**COMMENTS OF THE STAFF OF THE CALIFORNIA  
PUBLIC UTILITIES COMMISSION  
REGARDING THE CAISO UNIFIED ASSUMPTIONS & STUDY PLAN FOR THE 2019-  
2020 TPP FOLLOWING THE FEBRUARY 28, 2019 STAKEHOLDER MEETING**

**March 14, 2019**

Figure 7. In-state transmission zones in RESOLVE.

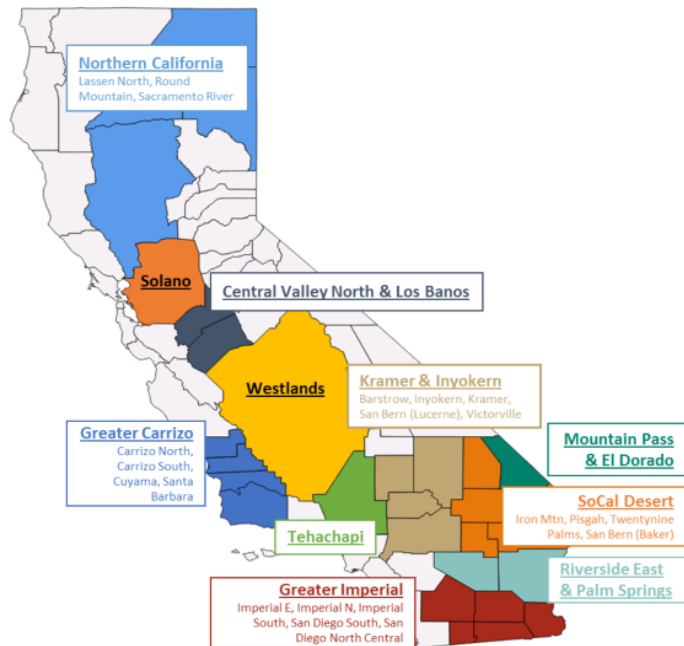
CPUC Staff wants to better understand how the 16 areas that will be studied under the reliability assessment compare to the “Transmission Capability Estimates and Costs CAISO Data (2019-2020 TPP)” document<sup>1</sup> and how CPUC Staff can better plan for modeling nested transmission constraints in IRP.

The CAISO does not speak in the Study Plan to the specific study areas used for the deliverability assessment. CPUC Staff requests that the CAISO please provide additional information in the Final Study Plan so that CPUC Staff can plan accordingly and determine whether it’s possible to adjust the RESOLVE model in a way that will allow for easier integration of nested transmission constraints. Both plans are included below for reference.
